**[Docket No. FAA-2024-0237; Project Identifier AD-2023-00491-R; Amendment 39-22853; AD 2024-19-11]**

### **Airworthiness Directives; Robinson Helicopter Company Helicopters**

Final rule.

Figure 1 to Paragraph (g)(1)(i)—Flex Plate Inspection

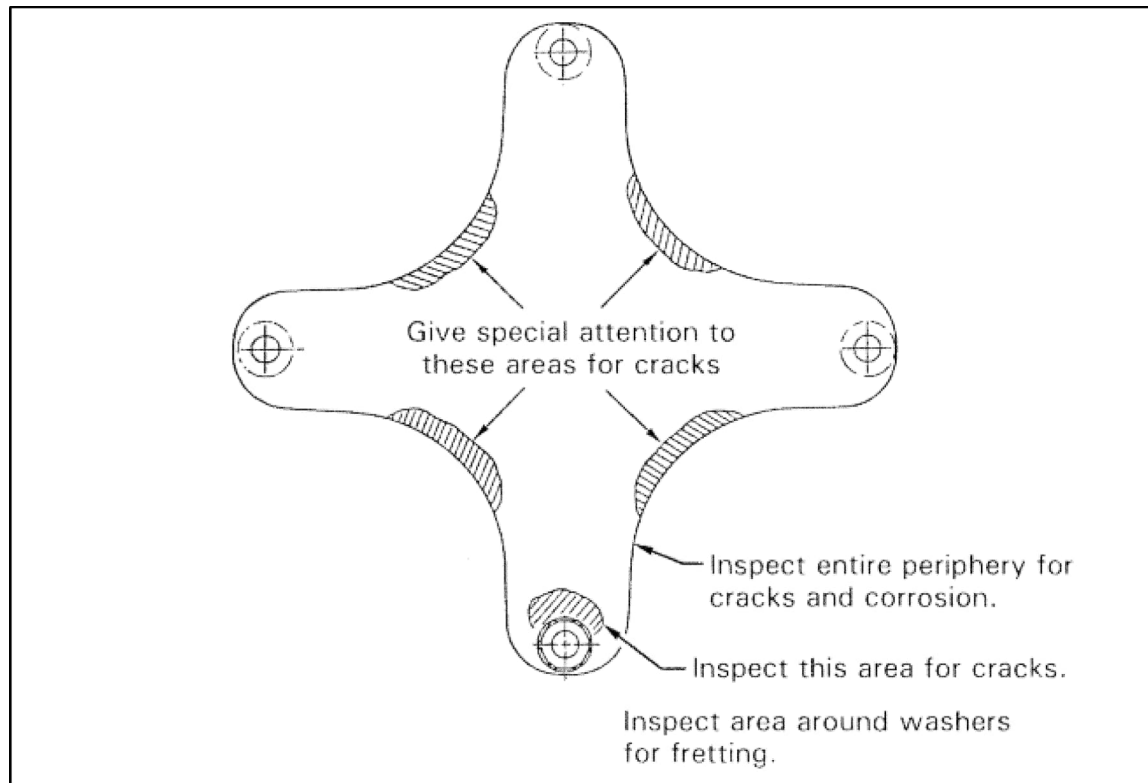
*Request:* Robinson Helicopter Company stated paragraph (g)(1)(iii) of the proposed AD requires ensuring that nut part number (P/N) D210-6 and palnut P/N B330-19 are installed. Robinson stated that per type design, only the two bolts on the flex plate assembly have palnut P/N B330-19 installed. Robinson Helicopter Company stated the wording in the proposed AD could cause some Model R44 helicopters to replace a yoke unnecessarily. Robinson Helicopter Company requested the FAA revise paragraph (g)(1)(iii) of the final rule to only apply to bolts shared with the flex plate assembly. Robinson Helicopter Company further stated it is possible some yokes do not have nut P/N D210-6 installed and would therefore also be subject to an unnecessary yoke replacement. Robinson Helicopter Company requested the FAA revise the wording of paragraph (g)(1)(iii) in the final rule to remove the reference to nut P/N D210-6.

*FAA Response:* The FAA agrees with these requests and revised paragraph (g)(1)(iii) of this AD to clarify that the inspection area is only for the flex plate assembly bolts and to remove any references to nut P/N D210-6.

(i) Visually inspect forward flex plate assembly (flex plate) part number (P/N) C947-1 for any loose fasteners, cracks, fretting, corrosion, wear, and to ensure that the washers are bonded to both sides of each flex plate arm, in the areas depicted in Figure 1 to paragraph (g)(1)(i) of this AD. If there is any loose fastener (can be moved by hand), crack, fretting, corrosion, or wear that consists of the

washers not securely bonded to both sides of each flex plate arm, before further flight, remove the flex plate from service and replace with an airworthy flex plate.
